Description of Revisions: This bulletin replaces the version dated March 2010. A new figure is added to clarify the components of the slip clamp assembly.

Early style bellows used on the CGI of EPA07 Caterpillar engines are prone to fatigue, which can lead to bellows failure and possible engine damage when not properly maintained. A new more robust bellows has been designed and is now available through the PDCs. See **Table 1** for associated part numbers.

Freightliner Service Bulletin

Fig. 1, Slip Clamp Assembly

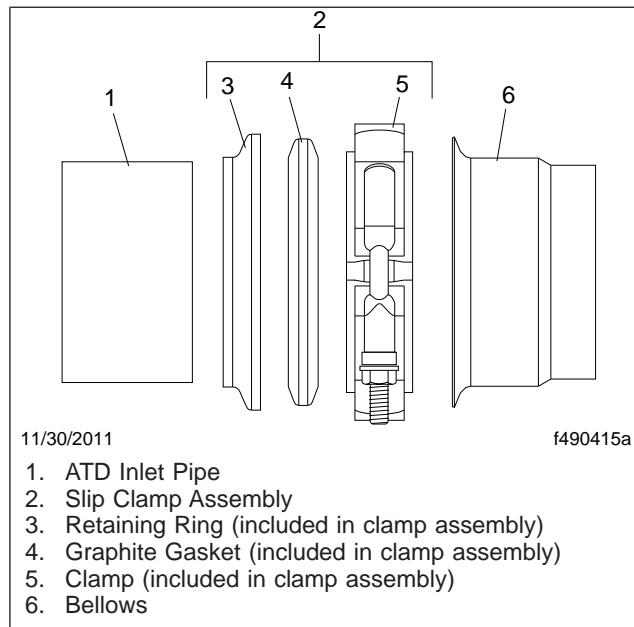
EPA07 CGI Exhaust Bellows Replacement Parts		
Description	Original Part Number	Replacement Part Number
CGI Bellows	04-24080-000 or 04-26501-000	04-29368-000
Clamp Assembly (2 each) See Fig. 1 .	TCPA25SD	TCX AMS030AM
